Re: Response to Technical Analysis and Request for Information,
Phase I Bond Release Application, Coal Hollow Mine, C/025/0005, Task ID
#4788

**Alton Coal's Response to Technical Analysis and
Request for Additional Information**

LOCATION MAP
PROPOSED PHASE 1 BOND RELEASE
 COAL HOLLOW PROJECT
 ALTON, UTAH
FIGURE 1

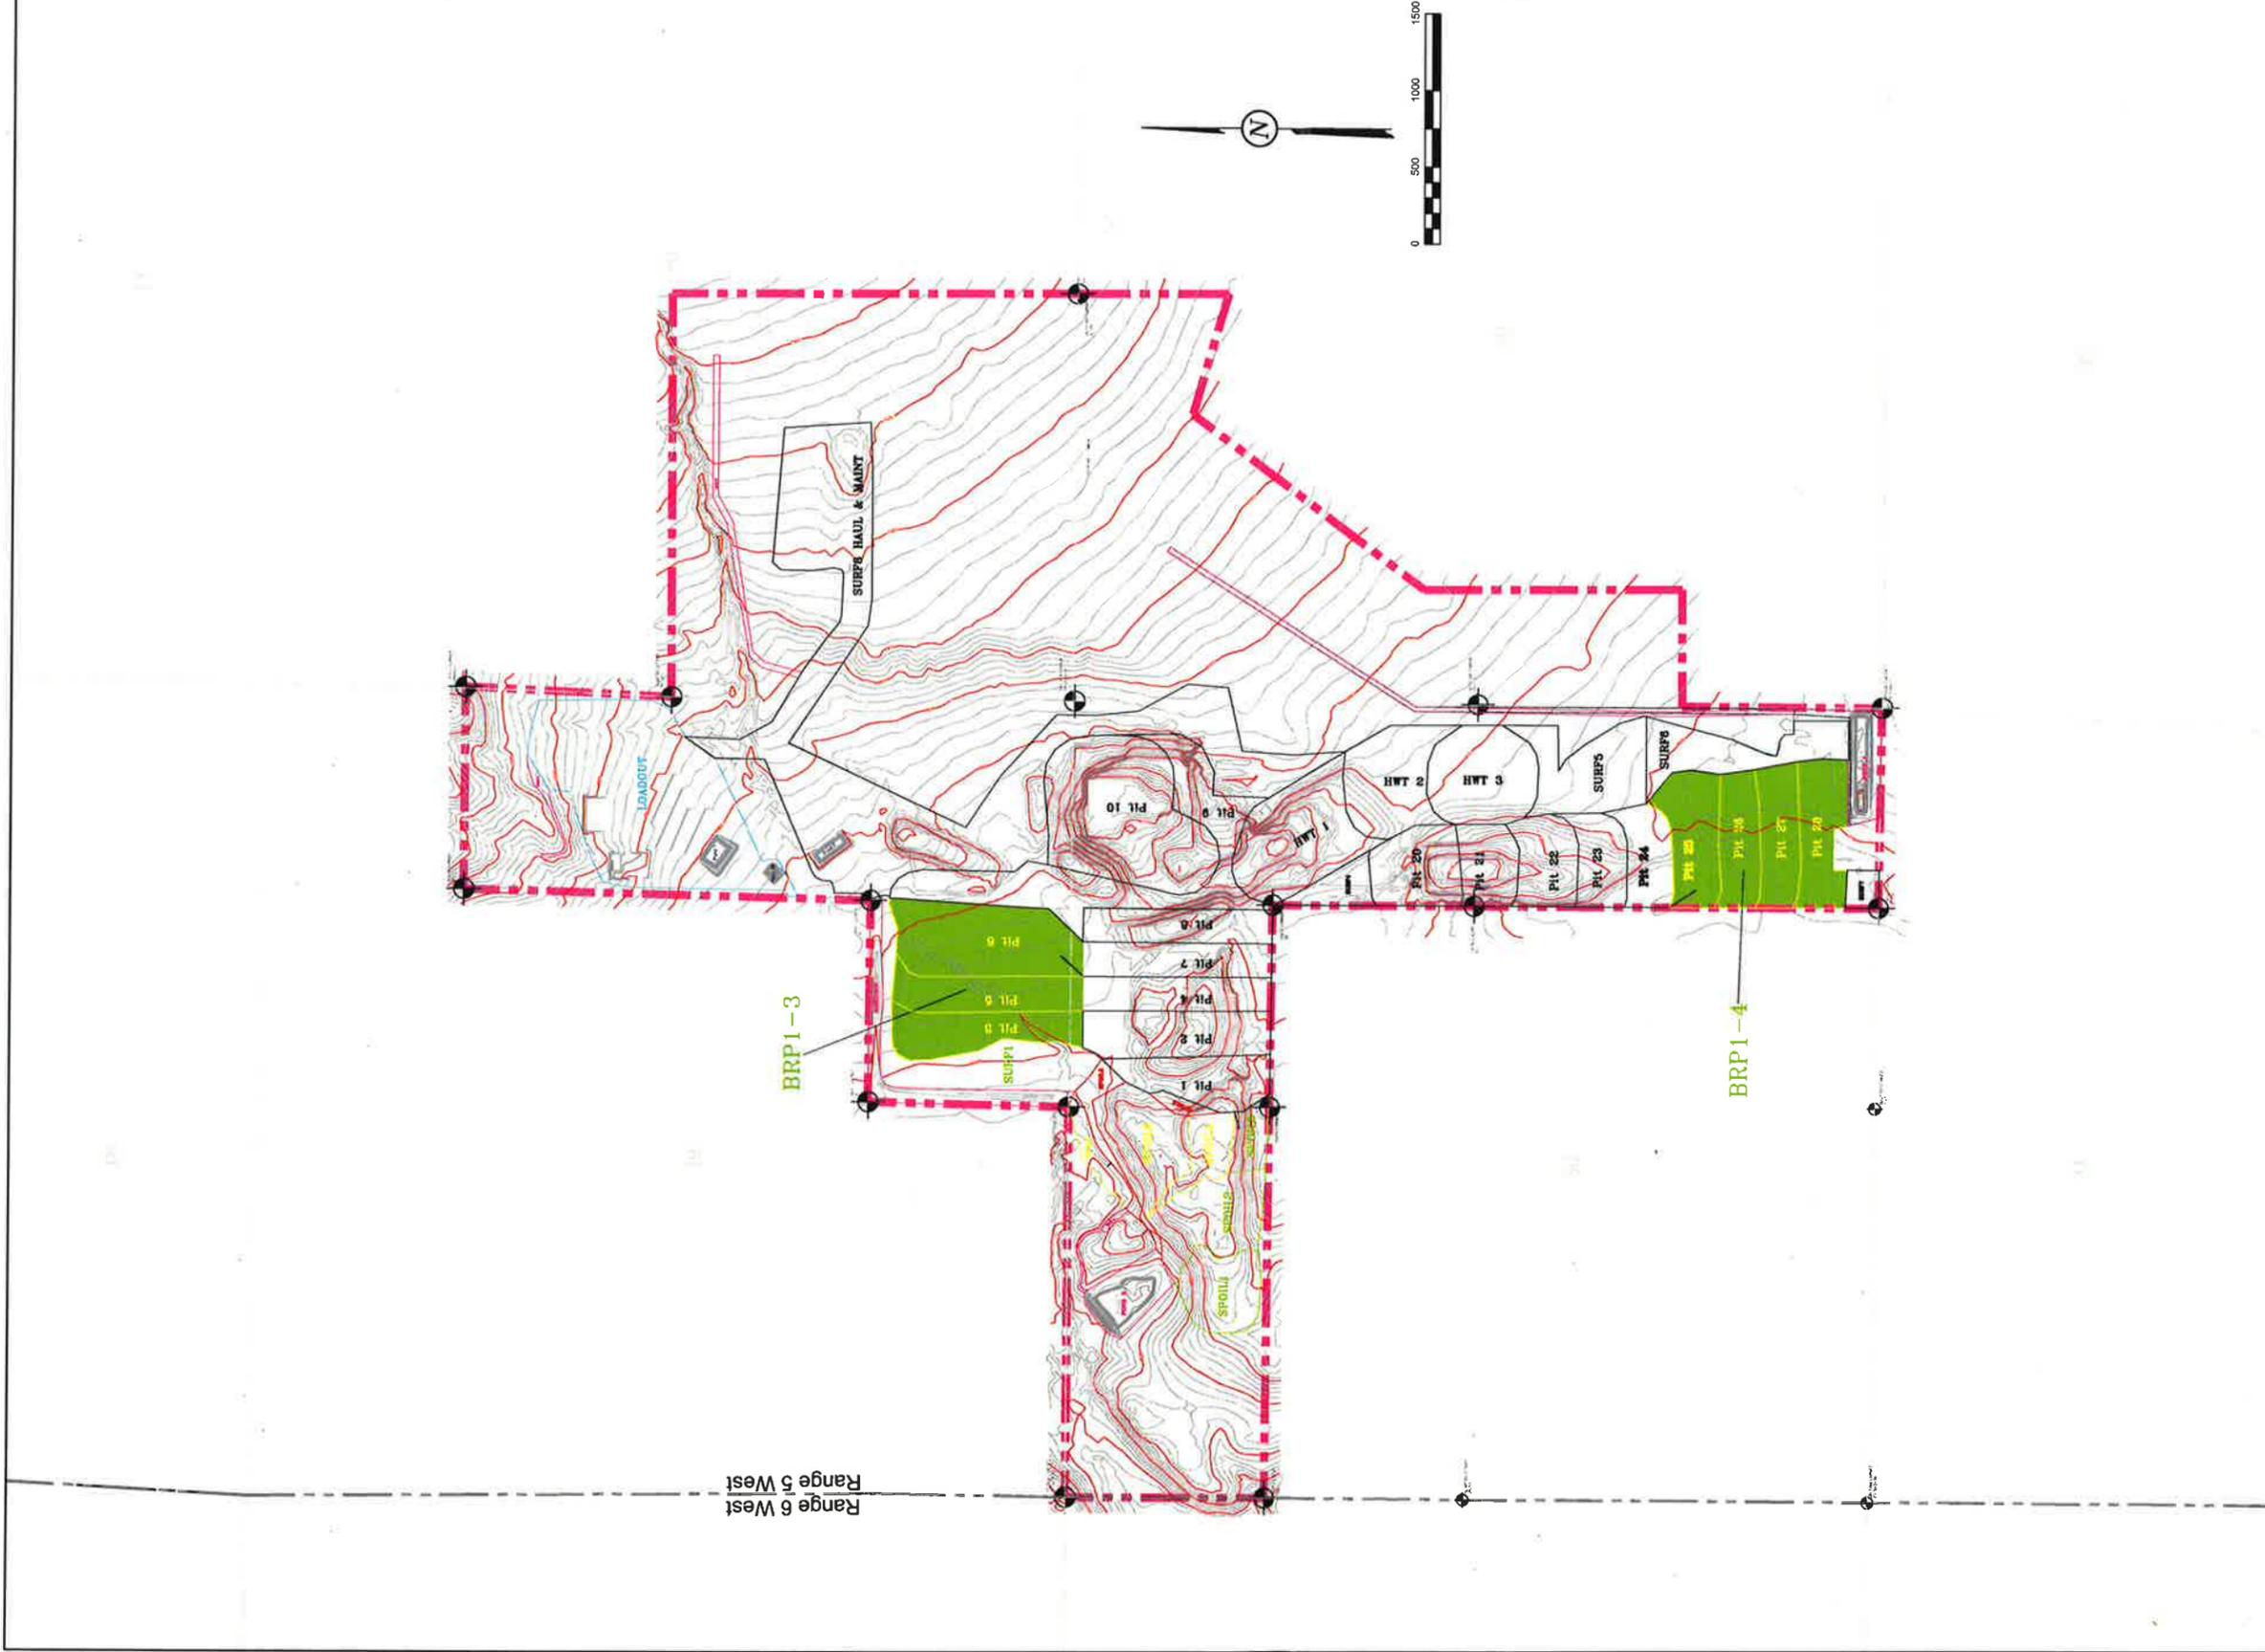
- The area detailed as BRP1-1 on Figure 1 within the application contains areas on the Excess Spoil pile that according to Figure 5-37 within the MRP and the current bond amount does not reflect the cost of removing the present subsoil. The section of BRP1-1 that contains sections Spoil 1 and Spoil 2, as detailed on the proposed Figure 5-39 in the response to DO-15A supplied 4/30/15, will meet the requirements of R645-301-553 for phase I bond release and will be surveyed and flagged by the Permittee to determine the new area, as shown on Division Figure A. The remain Spoil areas 3-8 will need addition subsoil removal costs added to the bond before they can be included in a Phase I bond release to meet R645-301-553.

- The area detailed as BRP1-2 on Figure 1 within the application contains the sections of Ditch 4. The application includes a requested release of 2.1 acres for said area, however, Ditch 4 is scheduled to be removed after reclamation therefore the area is not at final grade. The section of BRP1-2 that contains Ditch 4 does not meet the requirements of R645-301-553 for phase I bond release and will be surveyed and flagged by the Permittee to determine the new area, see Division Figure A.

- The area detailed as BRP1-3 on Figure 1 within the application contains the Lower Robinson Reconstruct. The application includes a requested release of 27.5 acres. The Lower Robinson Reconstruct as it is currently built is tied to a pending abatement plan from an NOV issued. The current design has yet to be approved by the Division and has additional work tied to it at final reclamation and removal of the northern "plug" therefore it does not have final grading approval. The section of BRP1-3 that contains Lower Robinson Creek reconstruct does not meet the requirements of R645-301-553 for phase I bond release and the area associated with the Lower Robinson Reconstruct will need to be surveyed and flagged by the Permittee to determine the area needing to be removed from the application. The Division estimates that the survey will likely result in changing the area associated with BRP1-3 to approximately 9 acres, see Division Figure A.

The application does not meet the minimum requirements of R645-301-542.200 as the Permittee failed to supply a map of the bond release reclamation areas in detail that matches any of the Final Surface configuration drawings within the MRP, Drawings 5-37 and 5-37A.

At this time Alton Coal Development will remove the Bond Release request on BRP1-1 and BRP1-2 as shown on Figure 1 (Attachment 2). The section of county road in BRP1-3 has been removed and the section of county road in BRP1-4 will remain as it has met the requirements as addresses in the previous Road Systems Plans and Drawings.

Drawings 5-37 "Post Mining Topography" is at 1":500', contours are 5' intervals. Figure 1 which has been submitted with this request has the same level of detail. The shapes for bond release have been reconfigured and with this submittal elevations have been added to the drawing

Figure 1 has been reconfigured with the new bond release areas and a new bond release amount has been determined from these bond release areas. Areas that will remain are BRP1-3 containing Pit 3, Pit 5 and Pit 6. The area of Robinson Creek has been left in as an approved design is pending, and there is a separate line item for the remaining surface work to be completed in this area. Diversion Ditch 4 is a surface feature constructed in the topsoil layer of BRP1-3 and its removal is not considered a phase 1 cost. Also, BRP1-4 will remain; this area contains the former Pits 25-28. Bond for these areas have been determined to have a bond release amount of \$10,748,693. Supporting documentation is attached with this submittal (Attachment 3).
